**Re: Monterey Bay Shore Ecoresort Project
A-3-SNC-98-114-EDD (Security National Guaranty, Inc.)**

Hearing: Dispute Resolution (Condition Compliance), May 15, 2015

CROSS SECTIONS PROVIDED TO STAFF

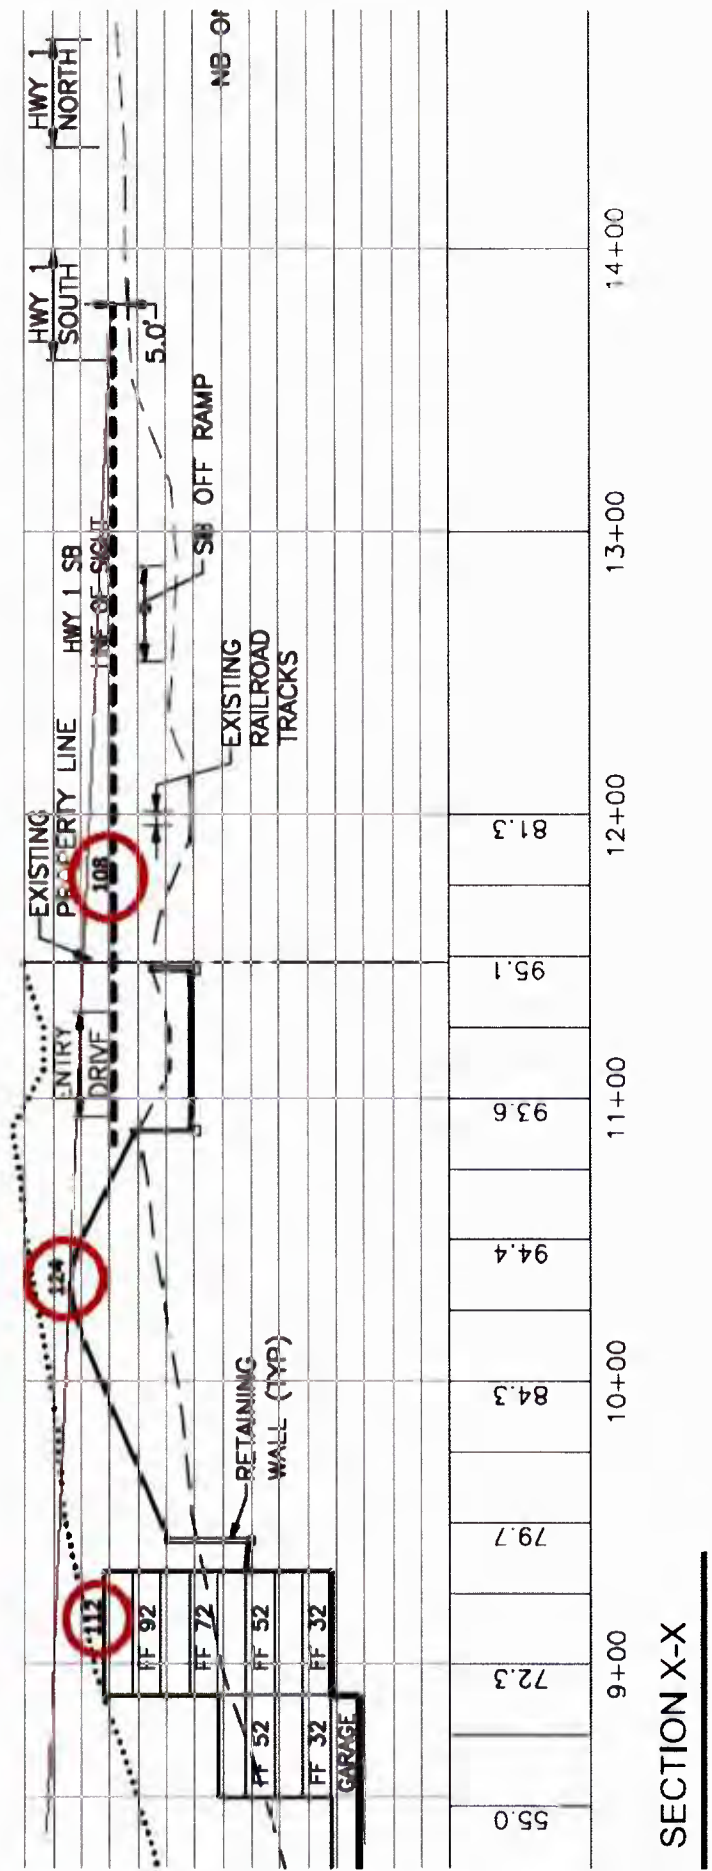
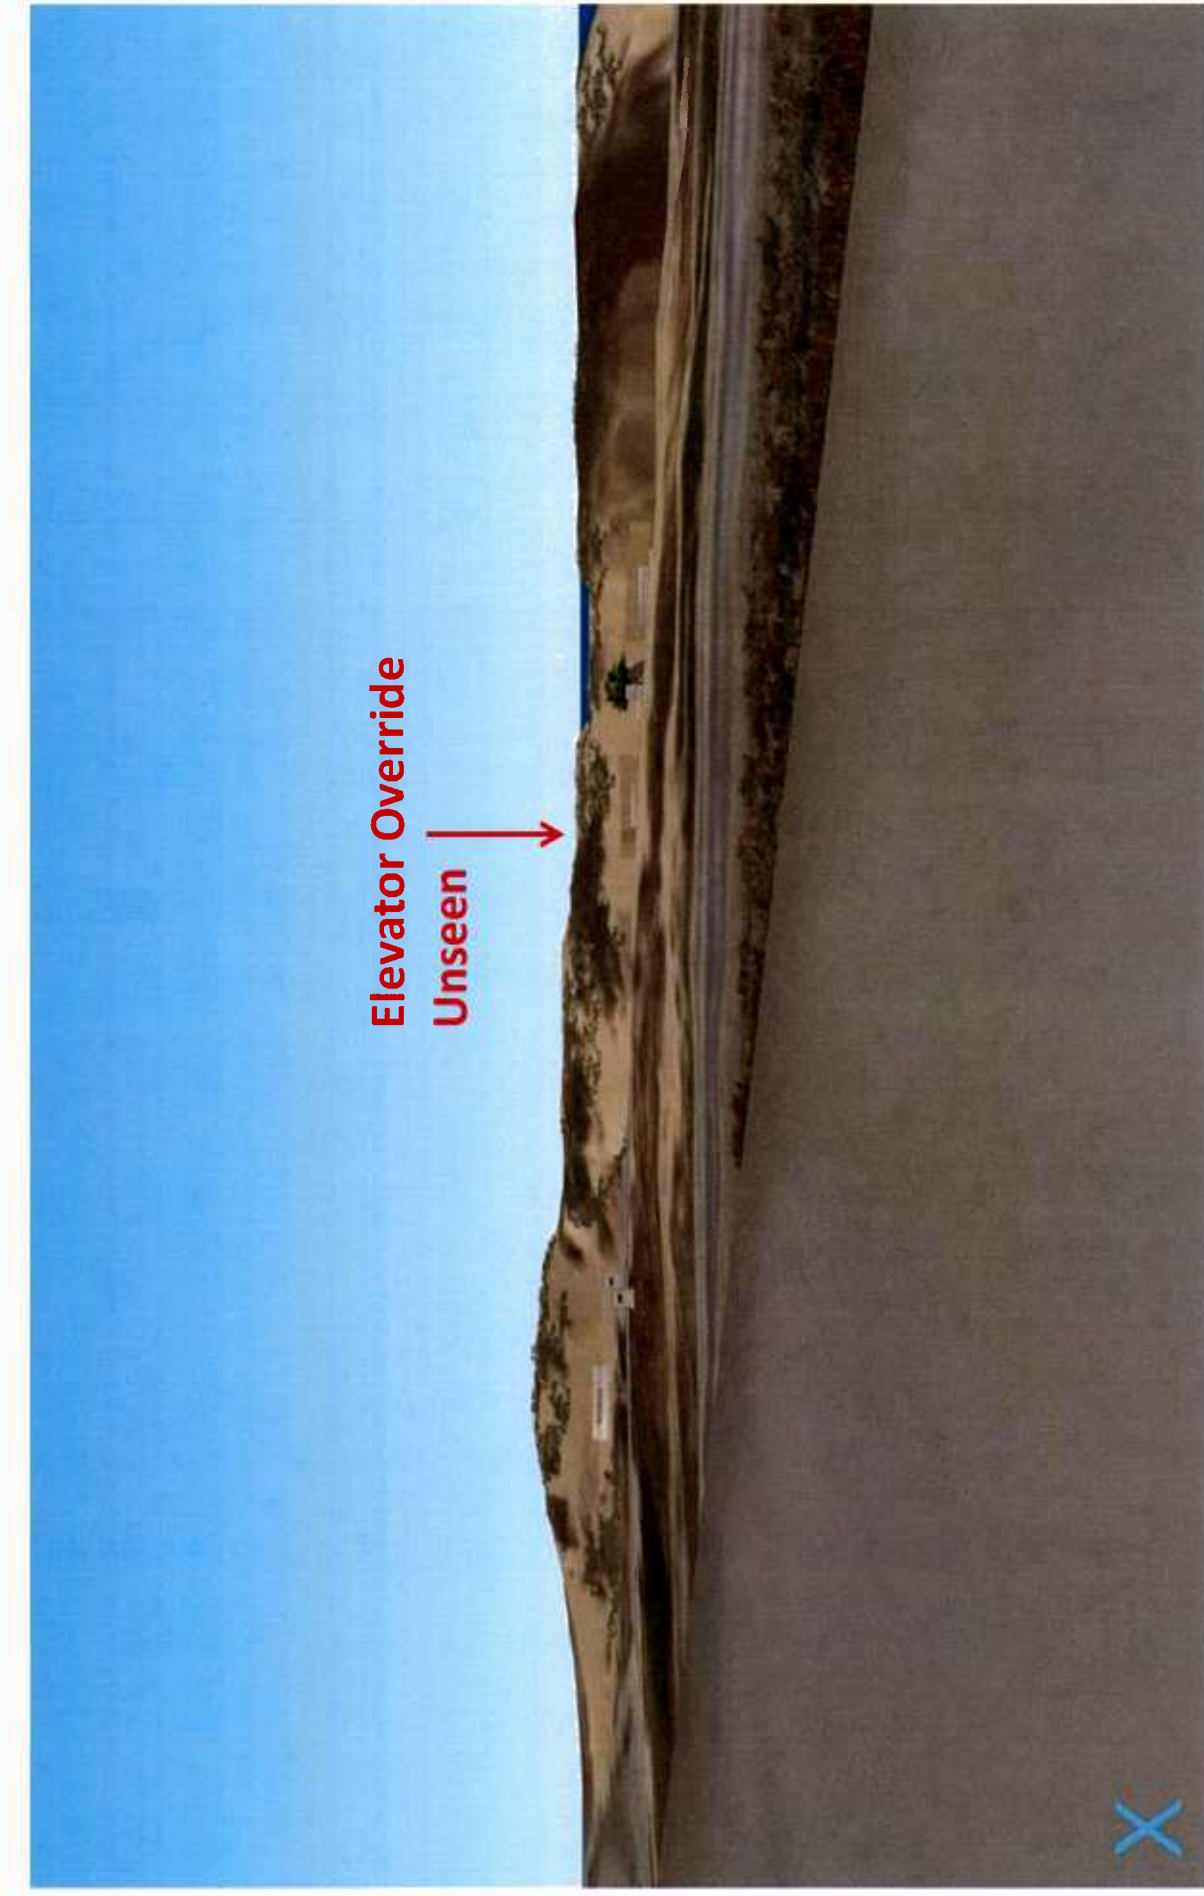
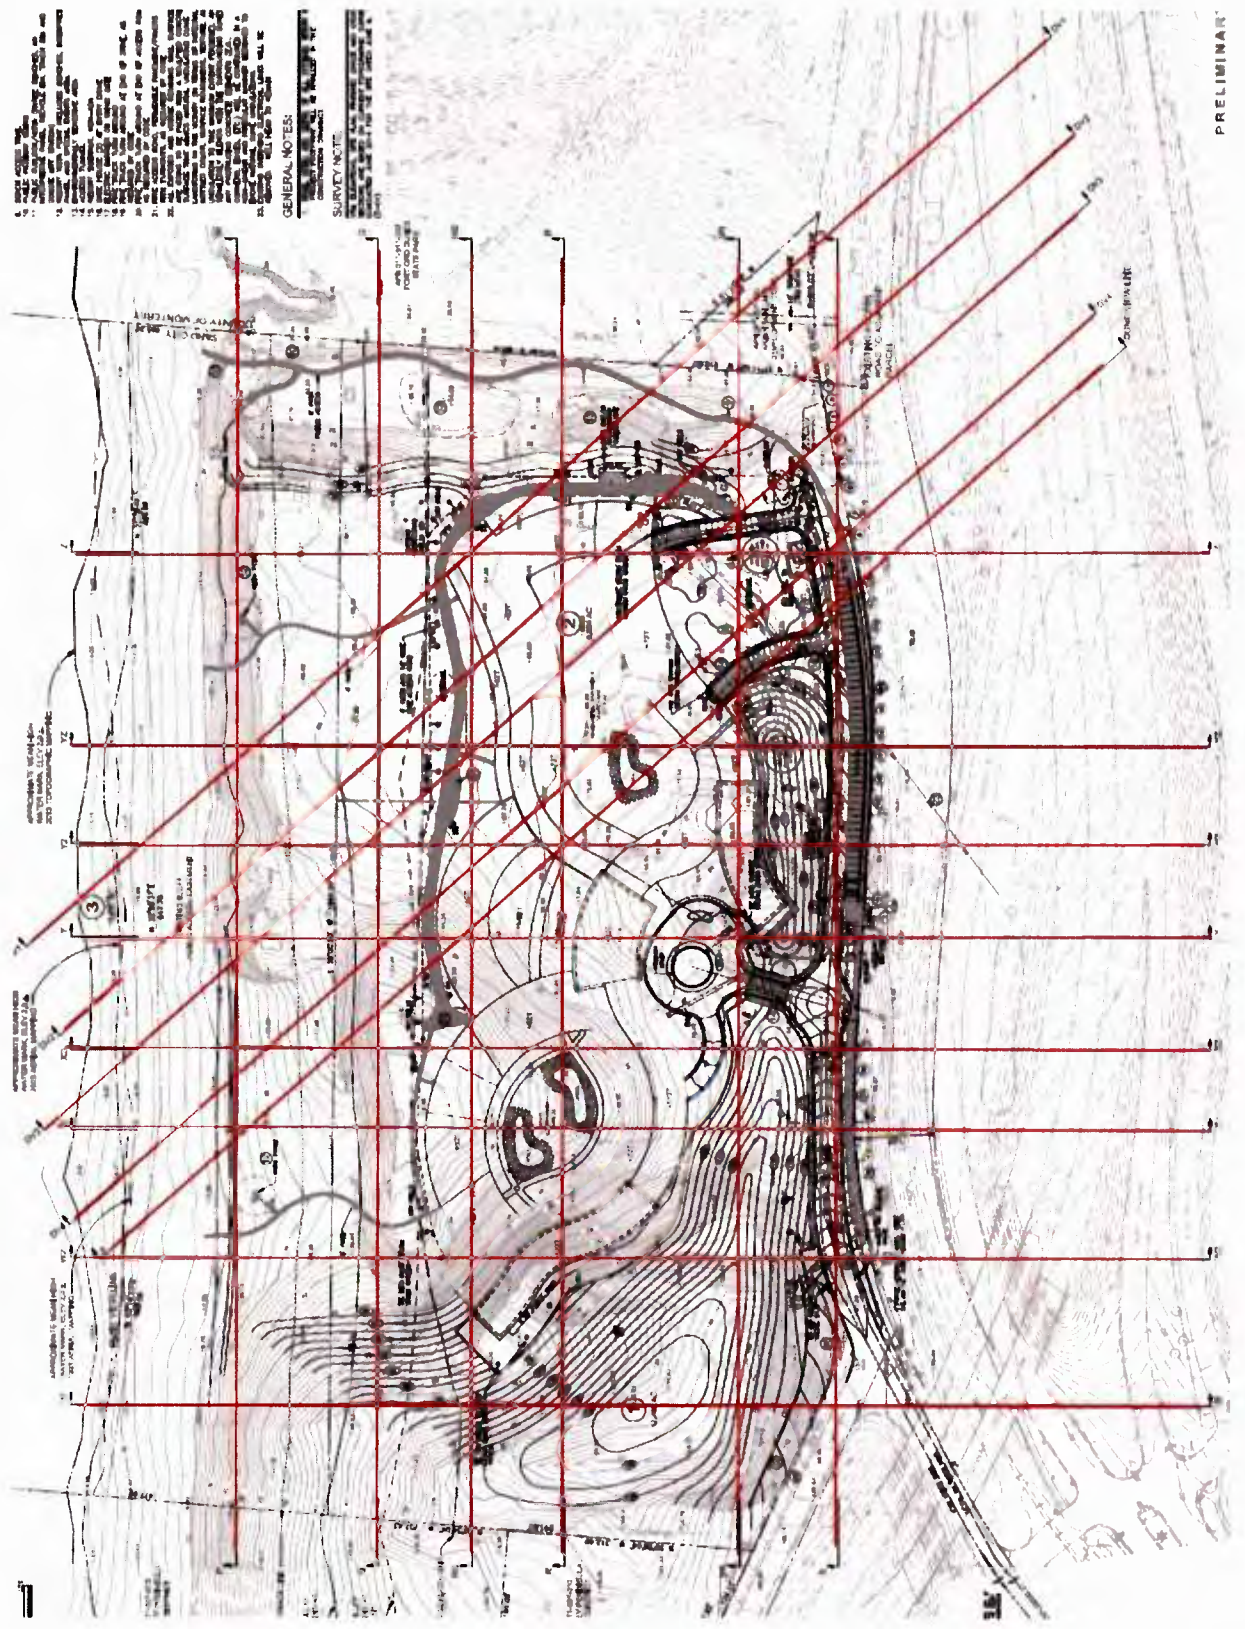
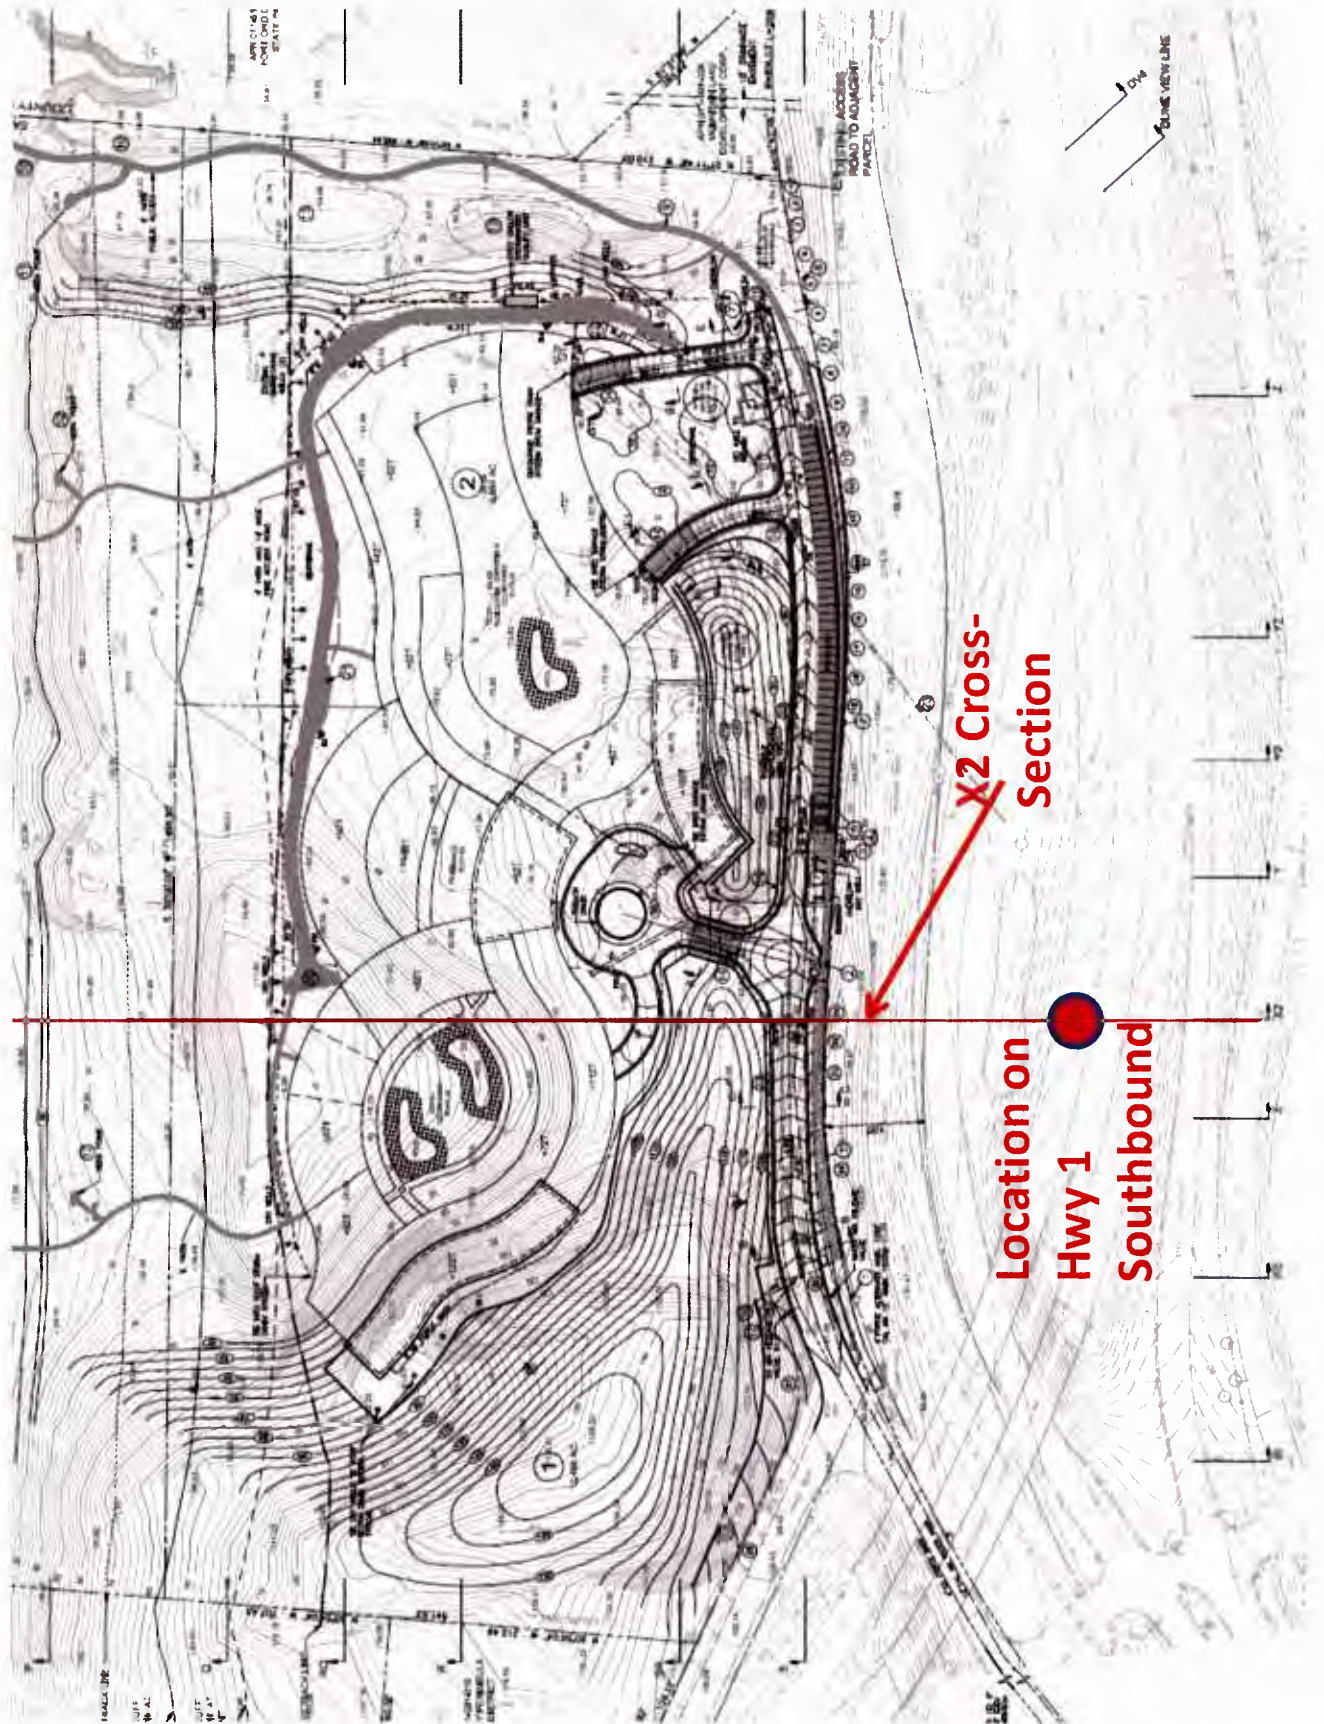
Project Plans Comply With “Building” View Requirements. The Revised Plans, extensive cross-sections across the Highway One frontage (no less than 13, plus 6 on the north end of the property – see the “master” cross-sections plan sheet which accompanies this letter as **Exhibit 9**), and Auto-CAD view simulations that SNG agreed to provide following its September 10, 2014 meeting with staff fully comply with the Settlement Agreement and Special Conditions 1 and 1(b). Nothing more is required.

For the first time, Staff now states that portions of buildings near the main resort tunnel also will be visible in the northbound Highway One view and those portions of the hotel and a portion of the residential building will be visible from Highway One views. The Staff Report again does not provide any indication of the locations that staff has in mind, but, importantly, all of the buildings are exactly at the heights agreed to in the Settlement Agreement and as shown on the approved VTM. Again, there is no deviation. Further, with one exception – well known to the Commission and fully discussed at the April 2014 hearing, none of the cross-sections that staff requested supports its claim.

SNG's Submission of Precise Site Plans, Cross-Sections, and Auto-Cad Renderings. Staff additionally argues that "architectural elevations" should also have been provided, beyond the extensive cross-sections (19 in number) and Auto-CAD view simulations submitted, which Staff agreed in a meeting with SNG on September 10, 2014 were the only deliverables necessary. The staff report is correct when it states that SNG has refused to expend yet more time and money in condition compliance to generate architectural elevations that are of no added value on the Highway One view issue.

Moreover, in this case SNG has provided 13 cross-sections to demonstrate the relation of Highway One to the restored dunes and the buildings. The cross-sections are engineering-wise absolutely precise. They are spaced across the Highway One frontage at varying intervals of approximately 90' (upcoast) and 50' (downcoast), and the Auto-Cad computer renderings are likewise precise engineering drawings in 3D and show the property from 5' above the Highway at a proper distance from the site. The building heights are accurate and conform to the approved heights in the Settlement Agreement, the VTM, and Special Condition 1 (introductory paragraph). The dune heights are plainly reflected on the VTM. The cross-sections and additionally the Auto-Cad view simulations are precise and accurate. The repeated assertion in the Staff Report that staff is hampered because SNG has not provided architectural renderings of all "four sides" of the Project argues for a useless exercise in terms of analyzing post-Commission approval the Project's compliance with Special Condition 1.

One further point bears emphasis. The Auto-Cad views were requested by staff, but despite the "reality" that staff seems to want, it told SNG to remove anything between the Highway One and the development area. So, what the Commission sees in the Auto-Cad view is not what one sees, in reality. It is what one sees only if the area is swept clean of any view obstructions in the foreground. To give the Commission a better sense of reality, SNG provides a "Z" cross-section and cross-section of the Dune View Line, each followed by the Auto-Cad view and then the view with the existing Cypress trees, vegetation, light standards, freeway signage and railroad tracks in the foreground off the property. These accompany this letter collectively as **Exhibit 13**.
